# 1 f) External Wall Treatment

**Heritage Council Comment 1 f)**

# 1 g) Internal Wall Treatment

# 1 h) Dead House Treatment

Figure 64: Detail of 'dead house' timber cladding

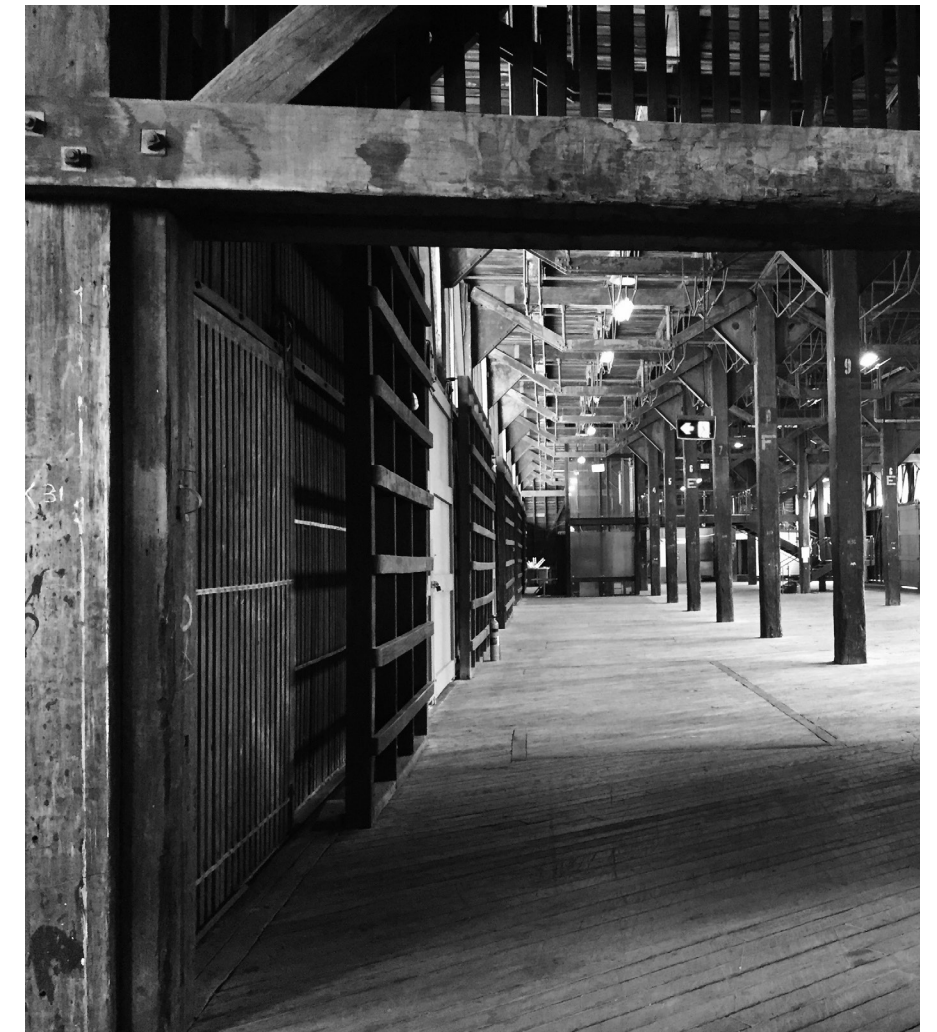
*The original 'dead house' is proposed to be reused as a box office/cloak room. Limited details have been provided regarding any changes required to house these functions with the existing space. Further design details of this space must be provided to the Heritage Council for assessment prior to approval of this project.*

The proposal involves the adaptive reuse of the timber slatted former 'Dead House', originally used for storing bonded goods, as a Cloak Room for Pier 2/3. The original fabric, including the timber screen that surrounds the space will be retained and conserved with the existing sliding timber screens made operable. The fitout of the space is the subject of design development, however, the design intent is that the free standing joinery including serving counter and cloak storage units are contemporary and reversible, as illustrated in the drawings overleaf.
